Product Change Notice

PCN#: EE-PCN23017

KR-5R5V105-R
KR-5R5V155-R

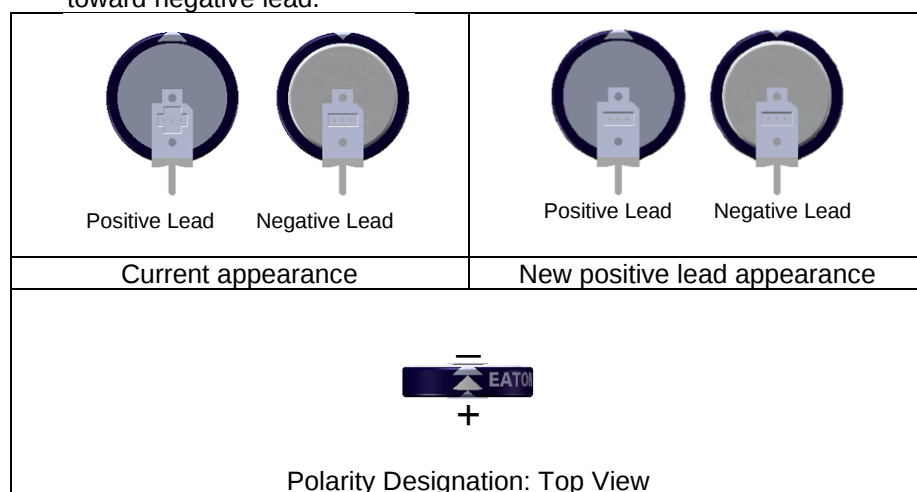
1. Tolerance of dimension P changing from ± 0.3 mm to ± 0.5 mm
2. Change of positive lead appearance. Polarity will continue to be determined by sleeve design pointing toward negative lead.

1. Specification to match actual production.
2. Quality improvement to avoid confusion with marking on the lead.
